Access Compliance Report Public Rights-of-Way (Curb Ramps)

Main Street: ANTONIO_PKWY Cross Street: N/A Location: W

ADA ID: RPAT220208125020 Ramp Type: Type 1 - Perpendicular Diagonal Initial Pass/Fail: Fail Overall Compliance: No Severity Score: 2

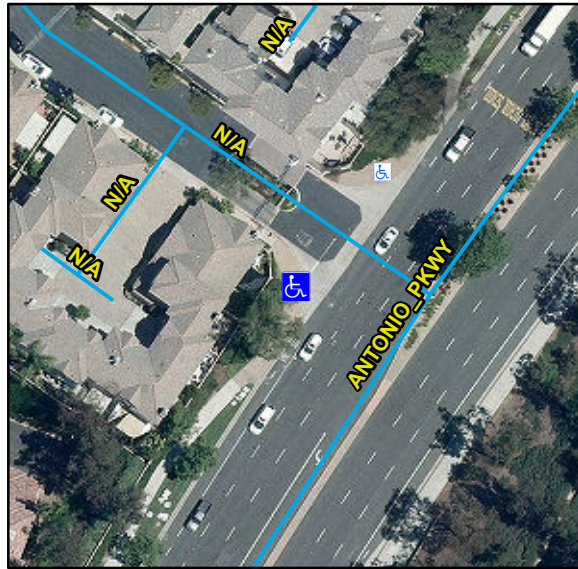
Compliance	Description	Data	Compliance	Description	Data
N/A	Ramp Length (in)	108	N/A	Flare Type LT	
Yes	Ramp Width (in)	60			N/A
Yes	Ramp Run Slope (%)	7.5	N/A	Flare Slope LT (%)	N/A
No	Ramp Cross Slope (%)	2.3	N/A	Flare Traversable LT	N/A
N/A	Landing Present	N/A	N/A	Flare Type RT	
N/A	Landing Length (in)	N/A			N/A
N/A	Landing Width (in)	N/A	N/A	Flare Slope RT (%)	N/A
N/A	Landing Run Slope (%)	N/A	N/A	Flare Traversable RT	N/A
N/A	Landing Cross Slope (%)	N/A	N/A	DWS Provided	N/A
N/A	Landing Movement Obstructed?	N/A	N/A	DWS Contrast	N/A
	Landing Movement Type	N/A	N/A	DWS Length (in)	N/A
N/A	Landing Shared	N/A	N/A	DWS Full Width	N/A
N/A	Clear Space	Yes	N/A	DWS Offset Left (in)	N/A
N/A	Clear Space To Crosswalk (in)	N/A	N/A	DWS Offset Right (in)	N/A
N/A	Marked Crosswalk 1	No	N/A	Marked Crosswalk 2	No
	Crossing 1 Direction	SE		Crossing 2 Direction	NE
	Marked Crosswalk 1 Width (in)	N/A		Marked Crosswalk 2 Width (in)	N/A

N/A	Ramp Inside Crosswalk 1	N/A	Yes	Ramp Inside Crosswalk 2	N/A
	Crossing 1 Slope (%)	1.9		Crossing 2 Slope (%)	5.9
	Crossing 1 Cross Slope (%)	0.52		Crossing 2 Cross Slope (%)	1.64
N/A	Gutter Ponding	N/A	N/A	Curb Slope	4.5
No	Gutter Lip Height (in)	0.25		Road Run Slope (%)	3.21
N/A	Gutter Run Slope (%)	N/A		Road Cross Slope (%)	5
N/A	Gutter Cross Slope (%)	N/A			
Yes	Overall Surface Condition: Acceptable		No	Perp Joint Present	No
	Cross Gutter Present?	Yes		Spandrel Present?	Yes
	Replace Cross Gutter?	No		Replace Spandrel?	No

Remove & Replace Curb Ramp With Two New Directional Ramps or Equivalent. Grind Gutter Lip.
